Bessie L. Martin Planning Director STAFF REPORT

Old Metairie Neighborhood Conservation District

Docket No. OM-31-23

Address: 314 Hector Ave.

FIGURE 7

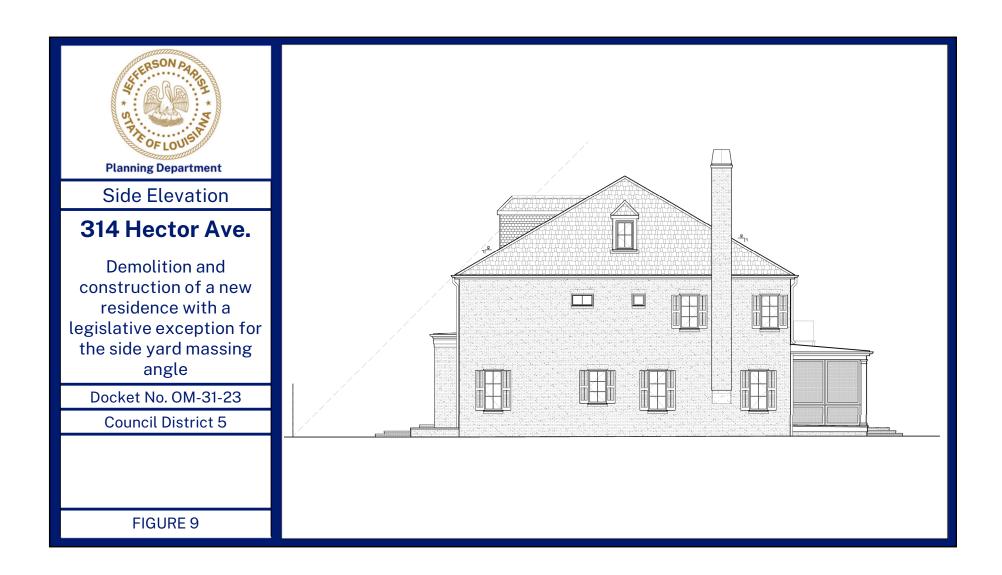
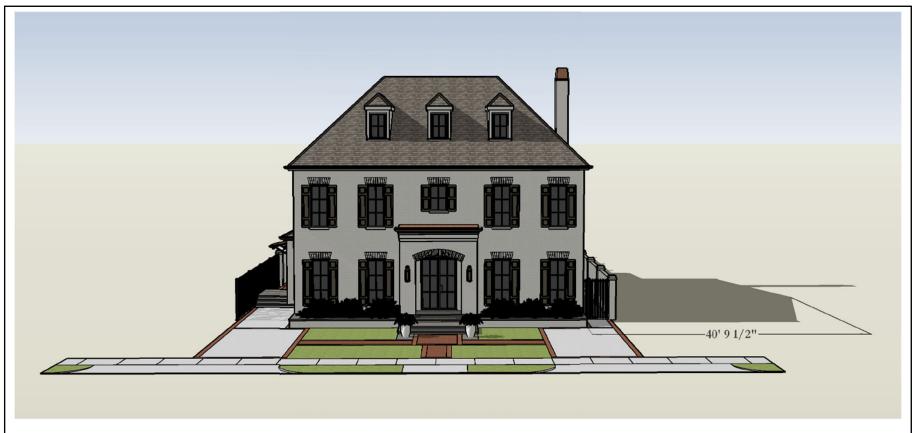
- 5. Per Section 33-3.65.3 (d)(2)a, no part of a proposed structure shall penetrate the lot's façade or side yard massing angle except for minor or incidental projections, as determined by the Planning Director. The roof by the Avenue B side penetrates the massing angle and as such a legislative exception is required.

- The legislative exception or variance is the minimum amount needed to relieve a hardship that is unique to the property: Although the legislative exception is not incidental, the requested legislative exception is a minor incursion of the side yard massing angle.

Proposed New Residence w/Gabled Roof (7:12)

Varience Not Required

Proposed New Residence w/Hipped Roof

Varience Required
